DTSP Update – Final Recommended Changes – Errata to the June 2009 draft DTSP Update  
 10/06/09  
 Attachment No. 1

# RECOMMENDED CHANGES

HUNTINGTON BEACH DOWNTOWN SPECIFIC PLAN NO. 3

Figure 3-35 Cultural Arts Subdistrict 1A Map

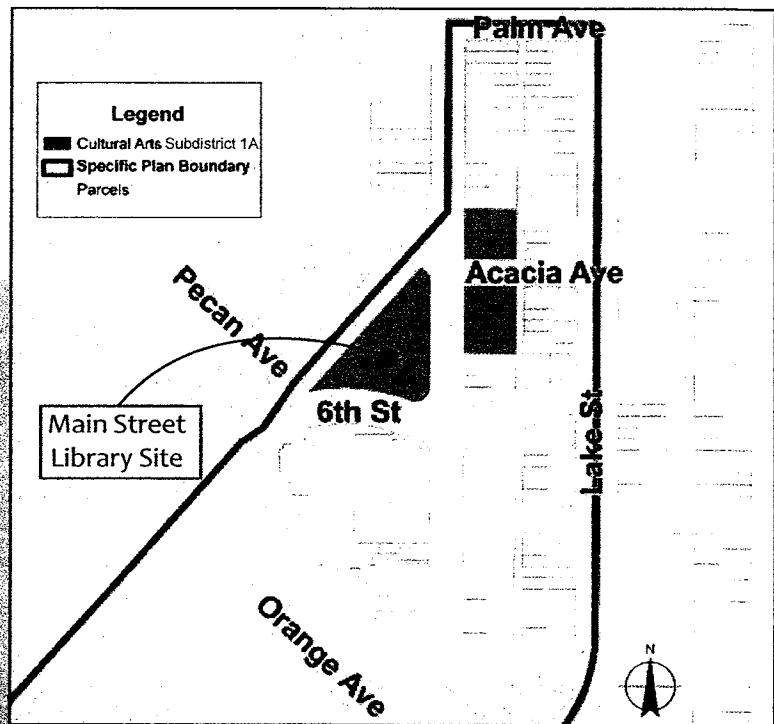
The Cultural Arts Subdistrict 1A consists of the triangular-shaped area and a portion of the blocks immediately north and south of Acacia Avenue and east of the Main Street intersection, as illustrated in Figure 3-35.

a) Cultural facilities uses are required at the ground floor street frontage in the Cultural Arts Overlay portion of District 1. Examples of cultural facilities uses include the following: library, museum, performing arts venue, and art gallery.

Figure 3-35 Subdistrict 1A Map

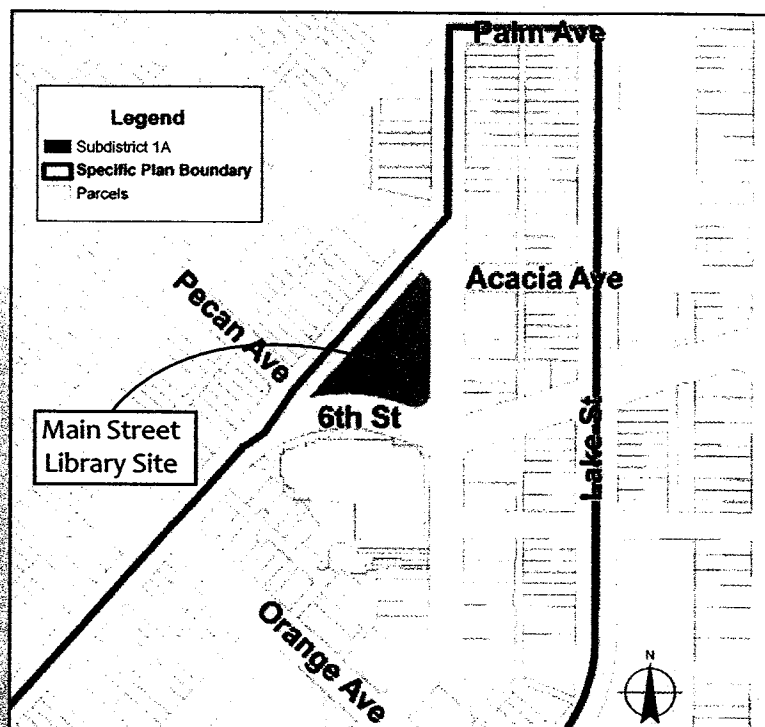
Subdistrict 1A consists of the triangular-shaped area bound by Main Street and 6th Street, as illustrated in Figure 3-35.

Figure 3-62. Tiered parking in District 7 shall be limited to the highlighted areas

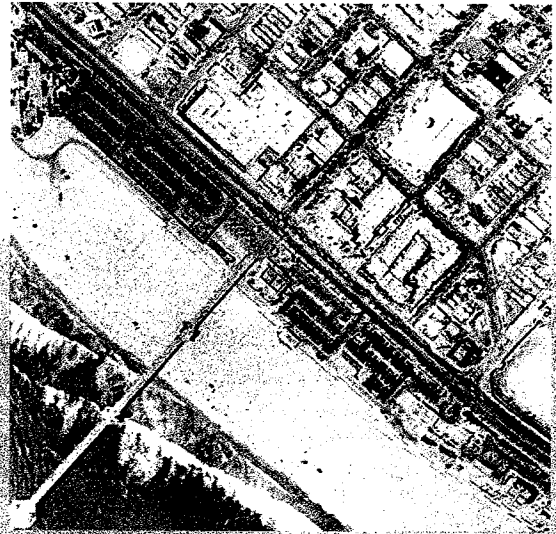
- Tiered parking shall be limited to the area identified in Figure 3-62.
- Parking shall not result in the loss of recreational sand area.
- The top of parking structures shall be at the same elevation of the Pacific Coast Highway sidewalk or located a minimum of one foot below the maximum height of the adjacent bluff.
- Views from and toward PCH shall be maintained.

Figure 3-63. Existing Condition: Tiered parking is permitted in District 7

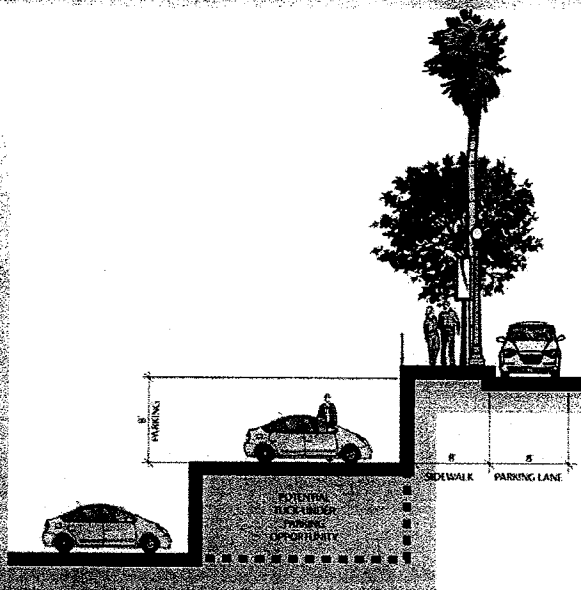
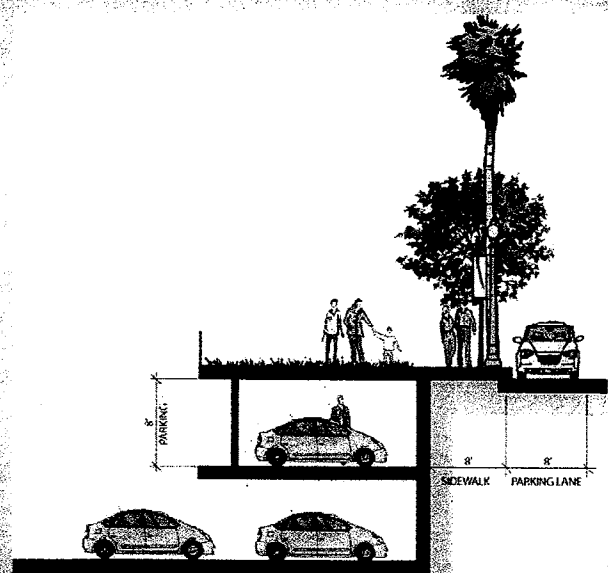
Enhancement of existing parking capacity located north of the pier between PCH and the beach is intended to enhance the pedestrian connectivity and experience along the west side of PCH and provide additional "tuck-under" parking opportunities. An expansion of the existing landscaped parkway reflecting similar design concepts and amenities found north of this area could be created by covering the existing upper tier of parking. In addition, "tuck-under" parking opportunities may exist by excavating versus expansion of the existing tiered parking height.

The precise design of additional "tuck-under" parking must adhere to the following standards:
